# TRI-STATE GENERATION & TRANSMISSION, INC.

## FOX RUN SUBSTATION DRAINAGE REPORT

Revise to "Final  
Drainage Report"

Add PCD File #  
PPR-22-044

**DRAINAGE BASIN DELINEATION**

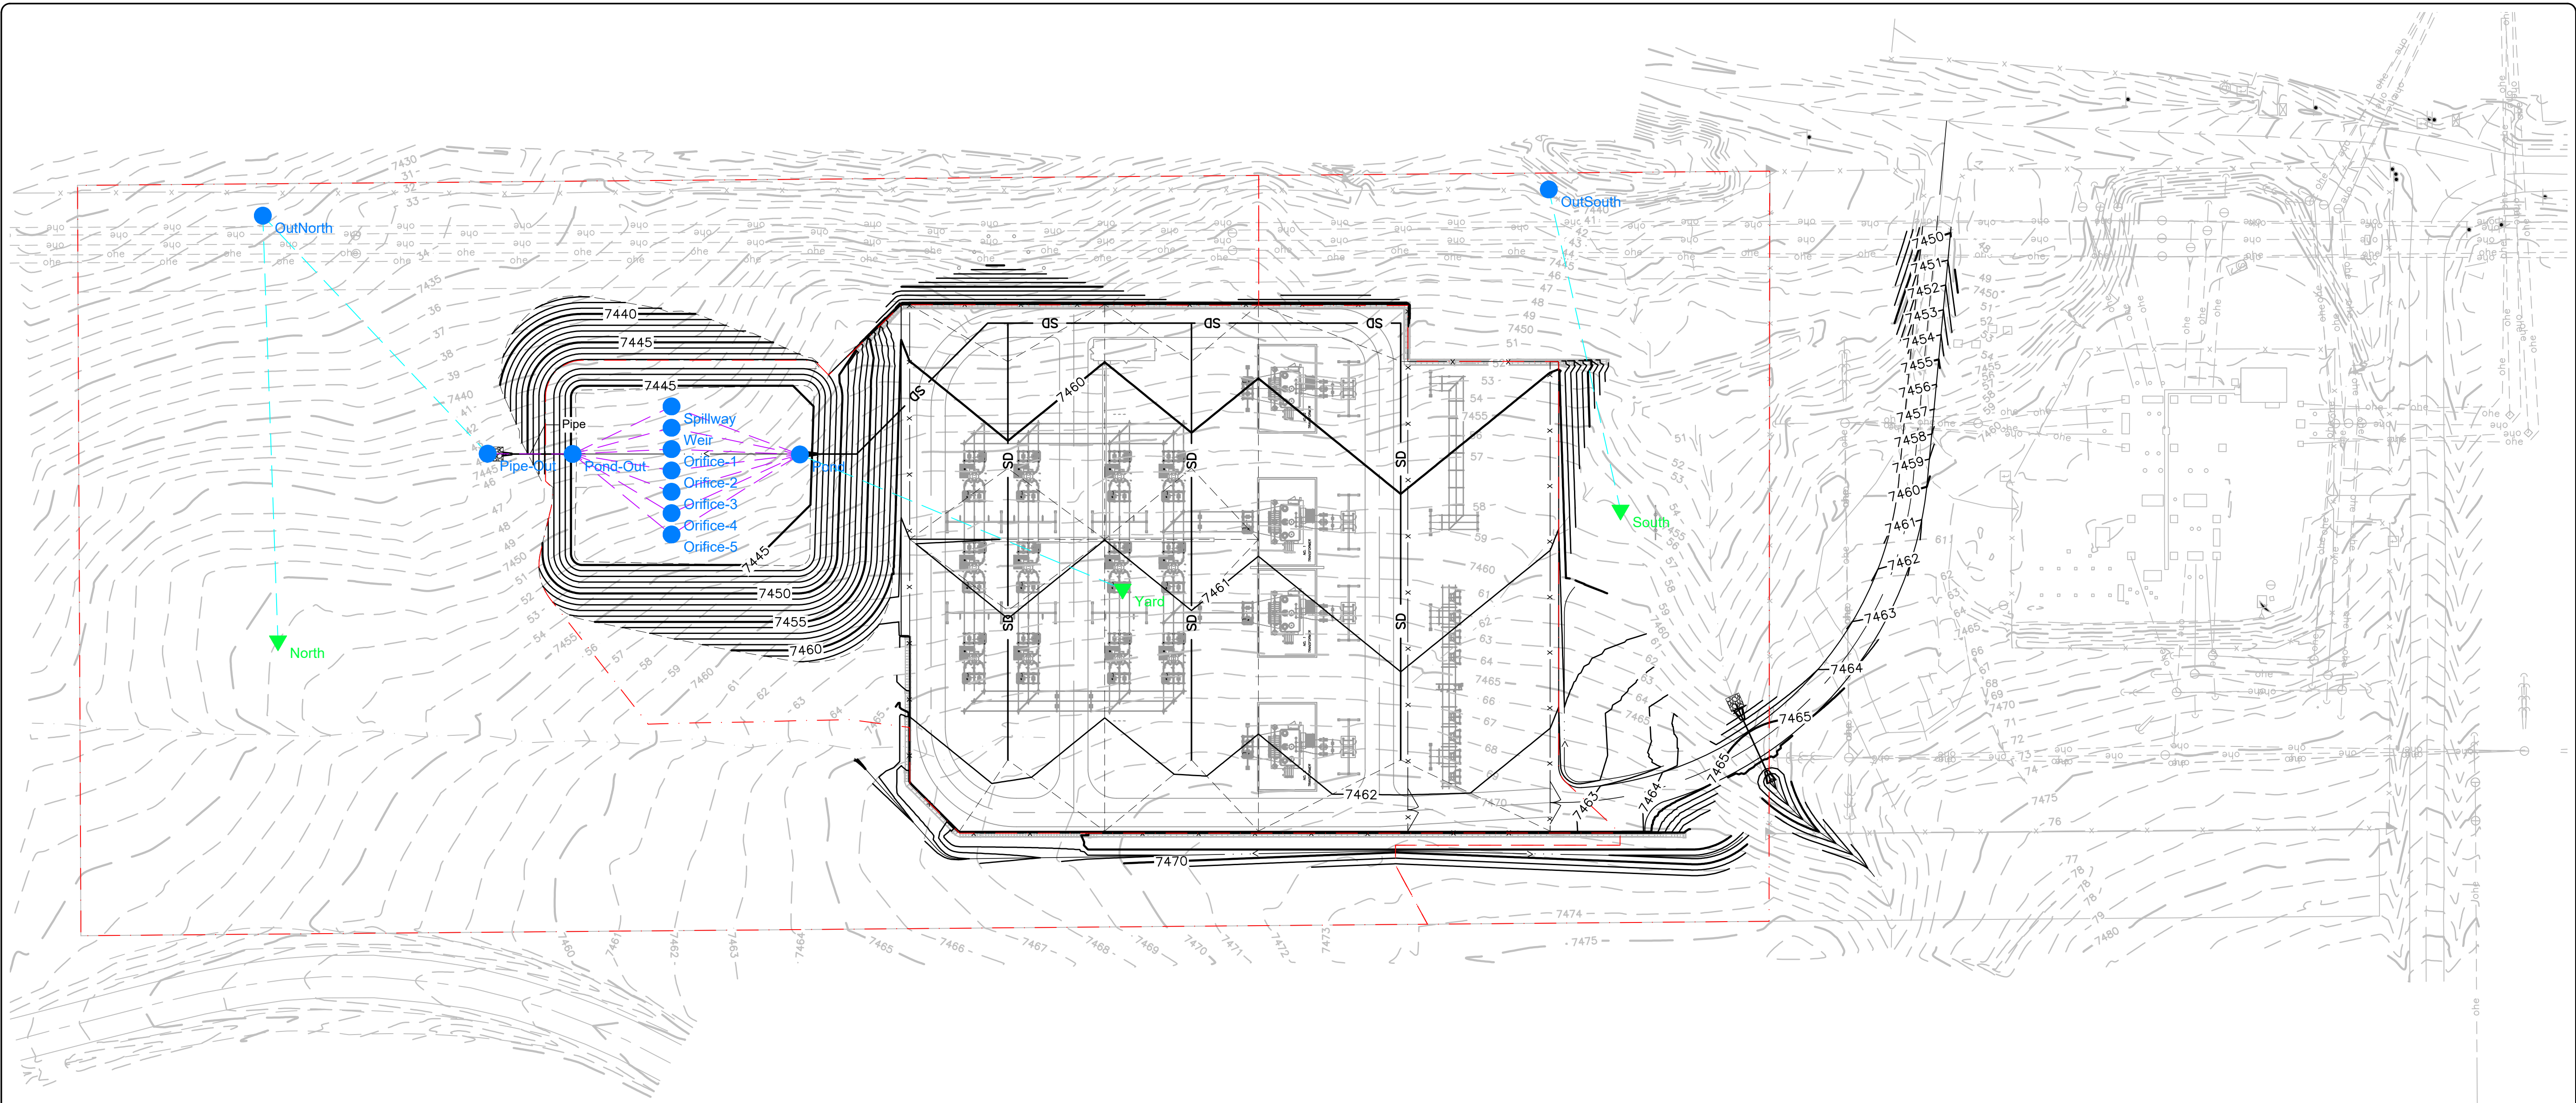
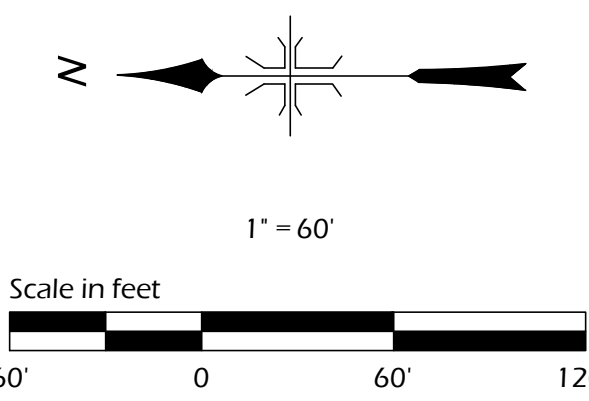
**Drainage Plan:** Map(s) of the proposed development at a scale of 1"=20' to 1"=200' shall be included to identify existing and proposed conditions on or adjacent to the site in question. It shall include a minimum of:  
 Existing and proposed contours at 2 feet maximum intervals. For subdivisions involving rural lots greater than 1.0 acre, the maximum interval may be 5 feet where approved. In terrain greater than 10% the intervals should be 10 foot intervals.  
 Property lines and existing or proposed easements with purposes noted.

**All Streets**  
 Existing drainage facilities and structures, including irrigation ditches roadside ditches, drainageways, gutters and culverts, all indicating flow direction. All pertinent information such as material, size, shape, slope and locations shall also be included.  
 Overall drainage area boundary and drainage sub-area boundaries relating to the subdivision.  
 Proposed type of street sections (i.e., vertical or ramp curb and gutters, roadside ditch, gutter flow and/or cross pans).  
 Proposed storm sewers and open drainageways, including inlets, manholes, culverts, and other appurtenances.  
 Proposed outfall point for runoff from the developed area and facilities to convey flows to the final outfall point without damage to downstream properties.  
 Routing and summary of initial and major flow rates at various design points for all storm runoff associated with the property.  
 Path (s) chosen for computation of time of concentration.

Details of and design computations for detention storage facilities including outlet.  
 Location and elevations of all defined 100-year floodplains affecting the property.  
 Location of all existing and proposed utilities affected by or affecting the drainage design.

# DETENTION BASIN STAGE-STORAGE TABLE BUILDER

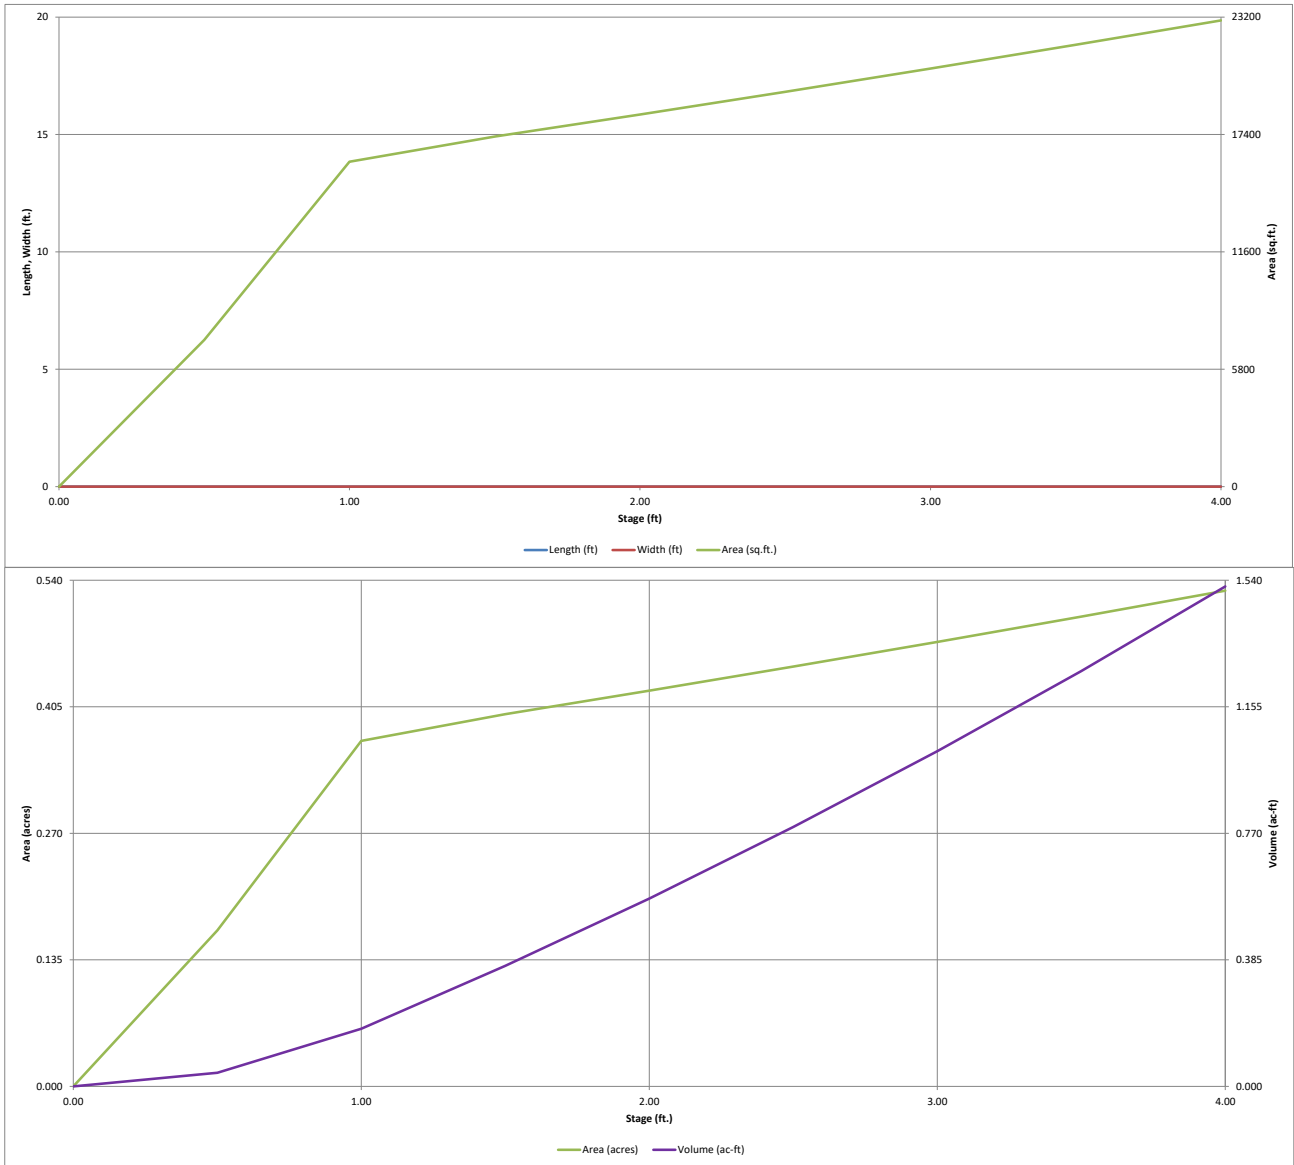
Revise Zone 2 to EURV and Zone 3 to 100yr - (Zone 1 & Zone 2)

## Routed Hydrograph Results

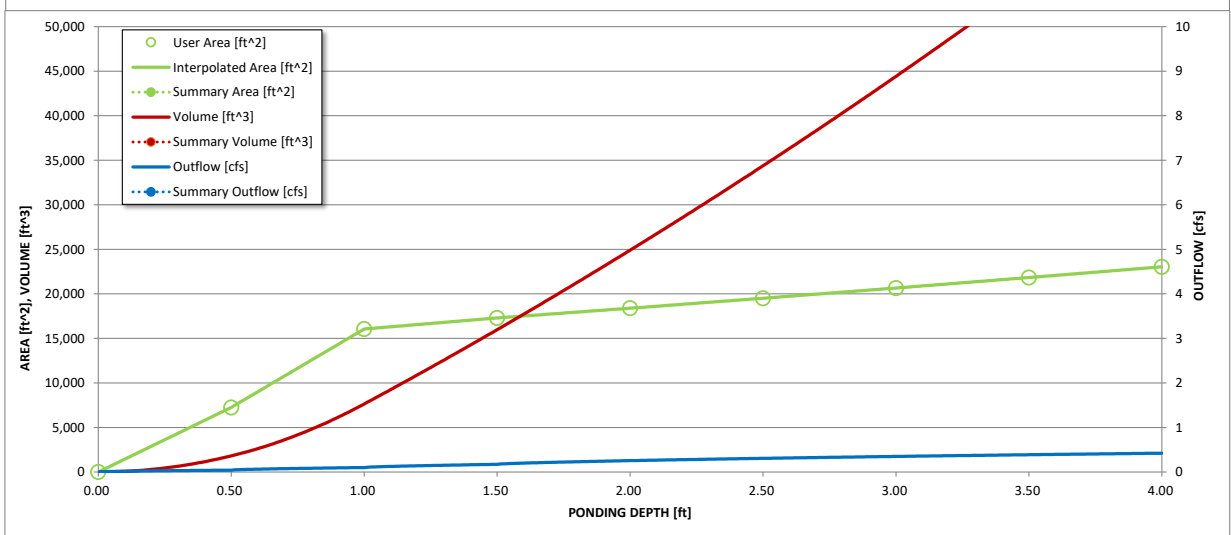
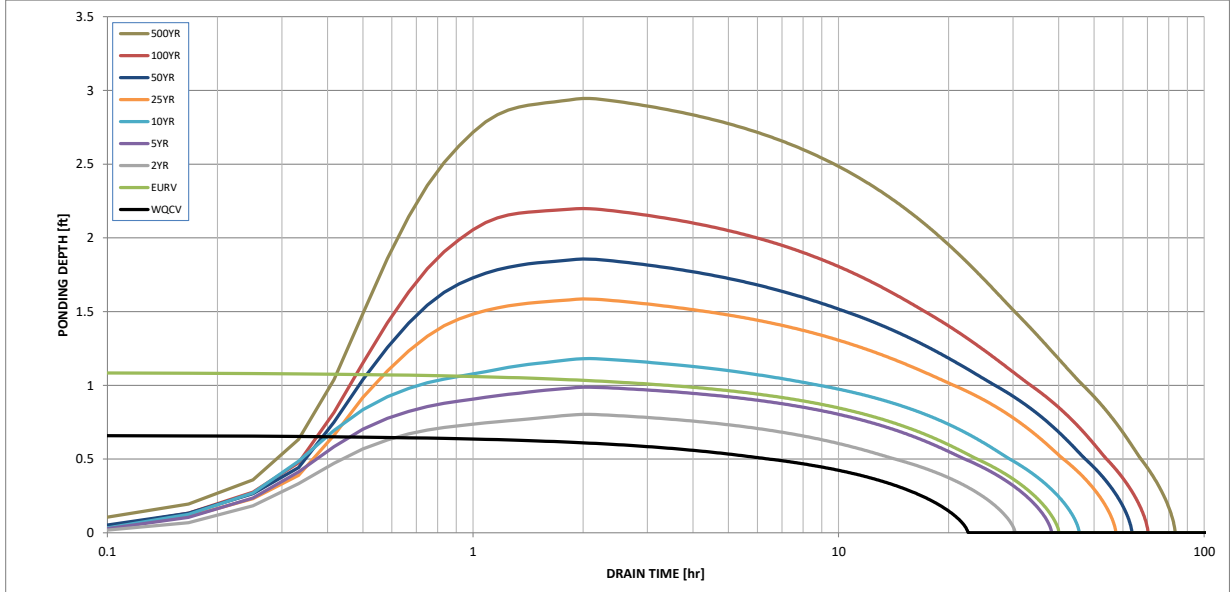
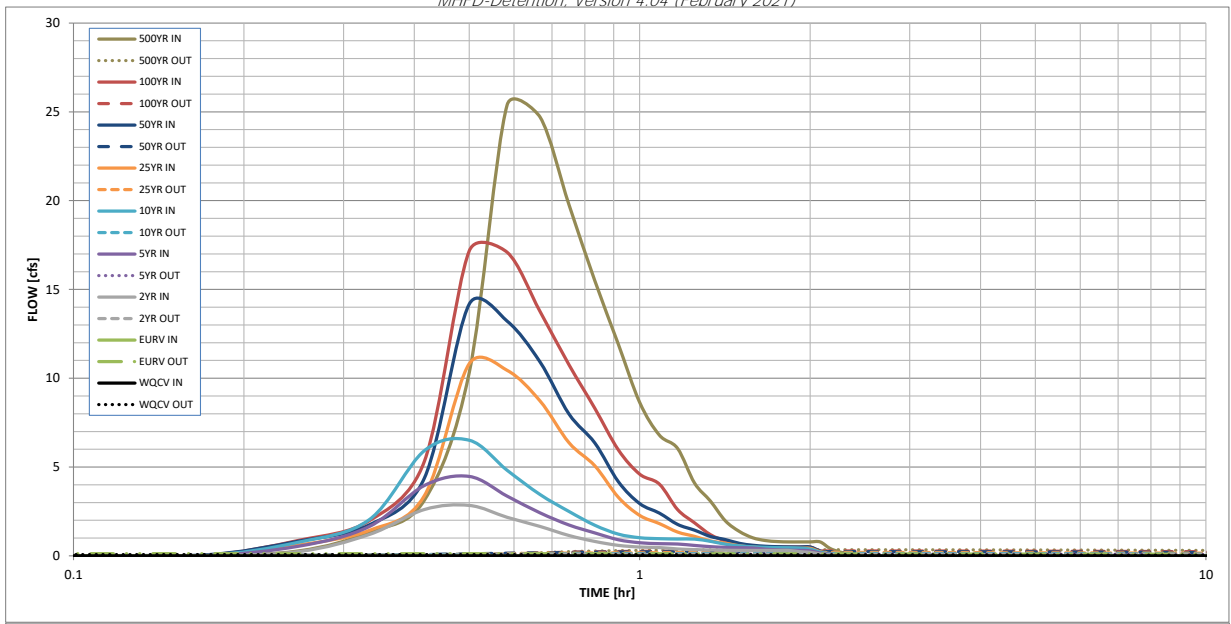
Revise to drain time of ~40hrs to ensure WQ
